4 August 2017

MP10_0044_MOD 2

SECTION 75W MODIFICATION TO BUILDING D, MONTEFIORE SITE RANDWICK

Figure 1 – King Street Elevation

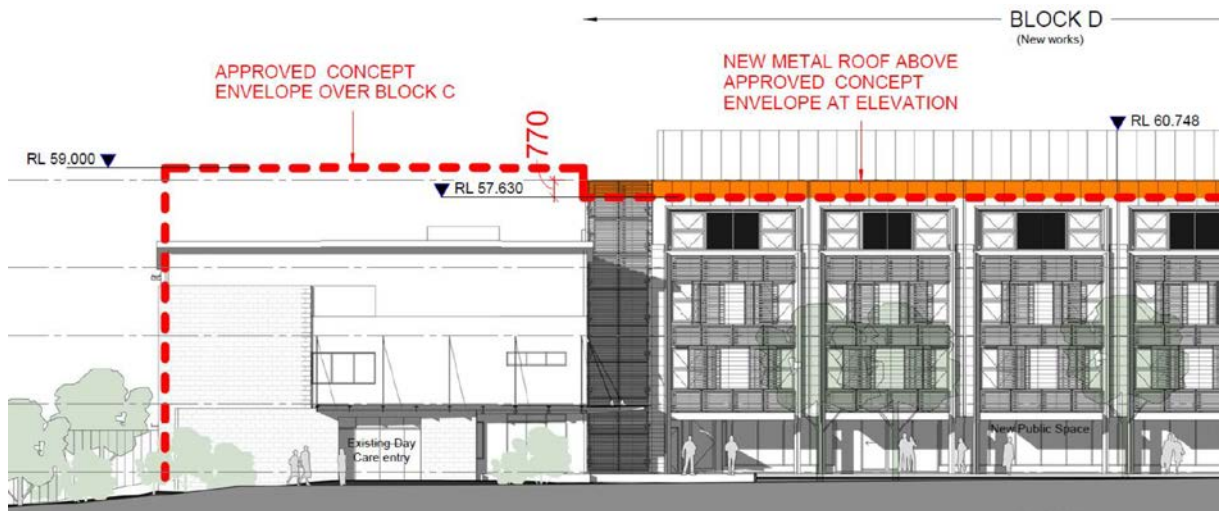
2.2.1. The 770mm 'parapet protrusion' along King Street:

- We note the protrusion is 770mm at the King Street and return parapets (ie worse case) with the metal roof raking down to the north, to a much lesser degree (refer to the King Street elevation and Section 1 extract in Figures 1 and 2 below).

- It is noted that this height does not exceed the total approved building height established by the roof plant of Level 7 and is contained below the approved height of Building C, and well below the overall approved height of Building E. Consequently, this minor protrusion of this part of the roof of Building D has no consequence in relation to view loss from those properties on the eastern side of Dangar Street looking west or north-west, nor buildings on the southern side of King Street (given the results of the visual impact assessment previously conducted as part of the Mod 2 process, and endorsed by the DPE and PAC).

- We further note that when viewed from the King Street frontage in context with Buildings E and F (ie in streetscape terms), the minor protrusion associated with the King Street parapet remains in keeping with these buildings.
- From an historical viewpoint, the height of this parapet has previously been contemplated and approved by the DPE in the original Concept Plan approval which showed a height to RL 58.53 at this location.
